PROJECT : ZK6

Size	Document Number	Rev
	USB_board	1A

Size	Document Number	Rev
	CARD READER RTS5159	1A

Model	REV	CHANGE LIST	MODEL	ZK6 FROM	ZK6 To

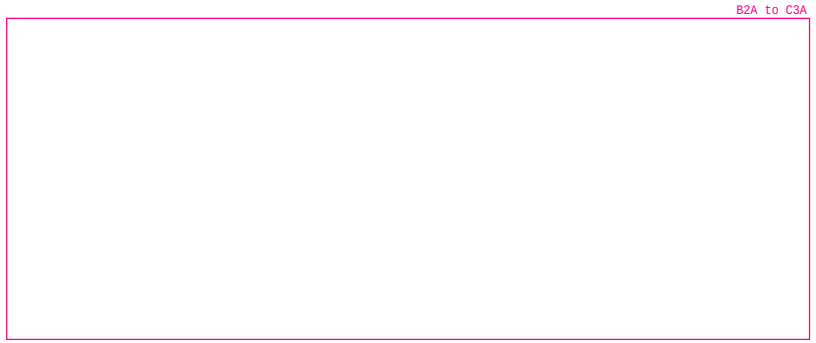
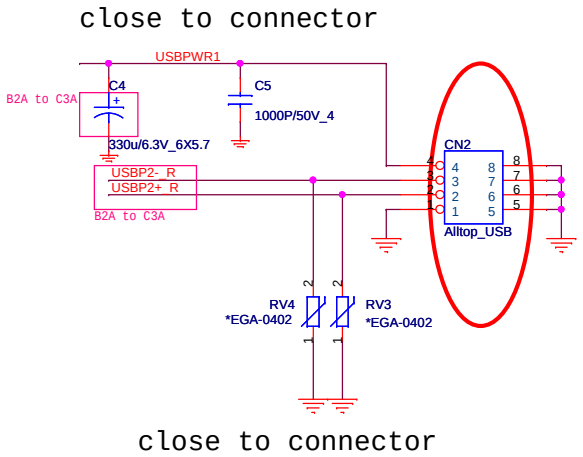
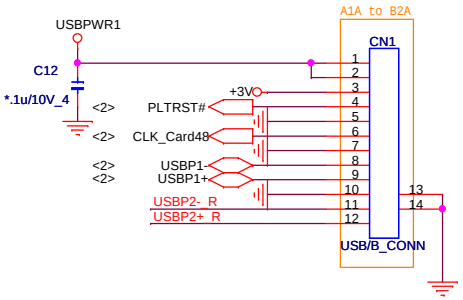
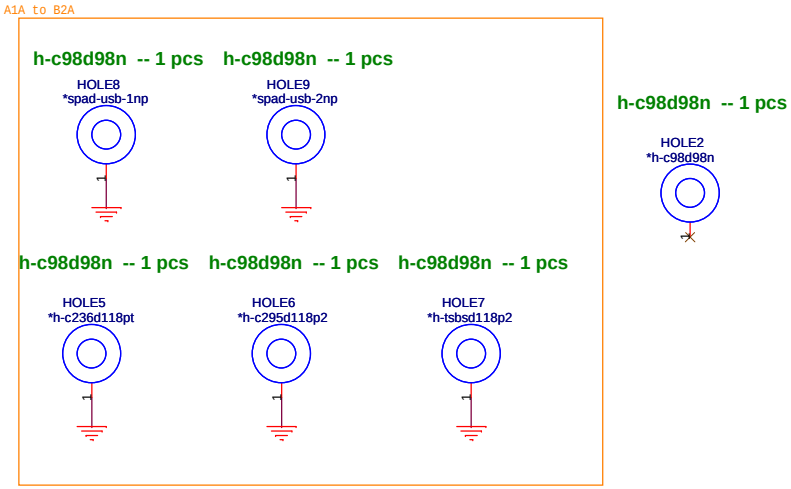
2009/02/03 item1 page01 CN1 change Part
2009/02/03 item2 page02 add Page02 component
2009/02/05 item3 page01 CN1 update footprint
2009/02/05 item4 page01 CN1 update footprint<88502-1201-12p-l>
2009/02/06 item4 page01 Delete HOLE1,3,4
2009/02/09 item5 page01 HOLE5,HOLE6,HOLE7,HOLE8,HOLE9 connect to GND
2009/02/12 item6 page01 C598,C367,C615 change to CH52201K991

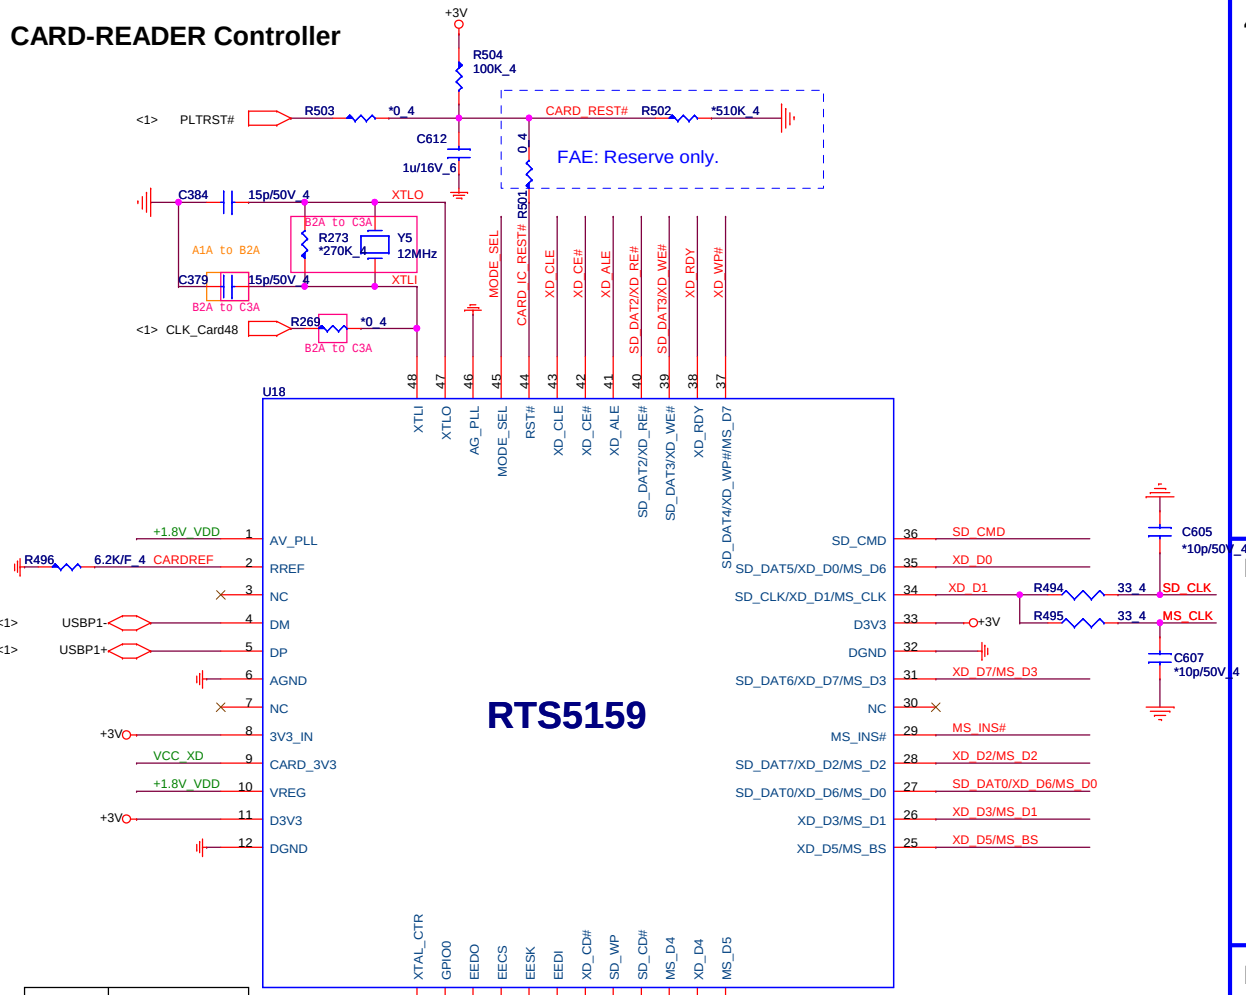
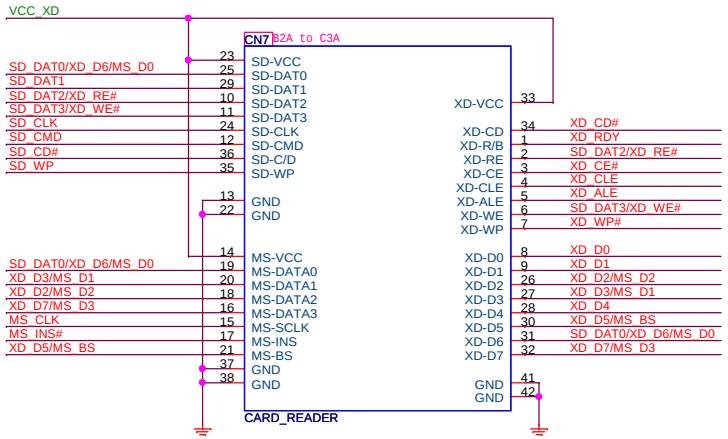
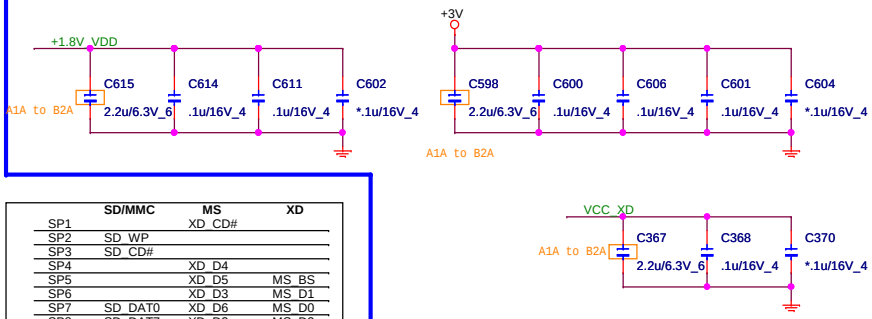
2009/03/02 item7 page02 CN7 change footprint from <4IN1-R015-212-LM-42P-H> to <4in1-r015-212-lm-42p-h-nb4>
2009/03/09 item8 page02 Y5,R273更換順序 出來先到晶振才到電阻電容
2009/03/09 item9 page02 R254 & R269 not stuff , C379 & Y5 should stuff
2009/03/11 item10 page01 delete R2,R3
2009/03/12 item11 page02 delete 0 ohm resistor 20 pcs<R250R251R252R253R255R261R262R263R264R265R267R271R272R278R281R282R283R284R285R286>
2009/03/12 item12 page01 C4 change from<CH71001M687>to<CC73301MZ00>
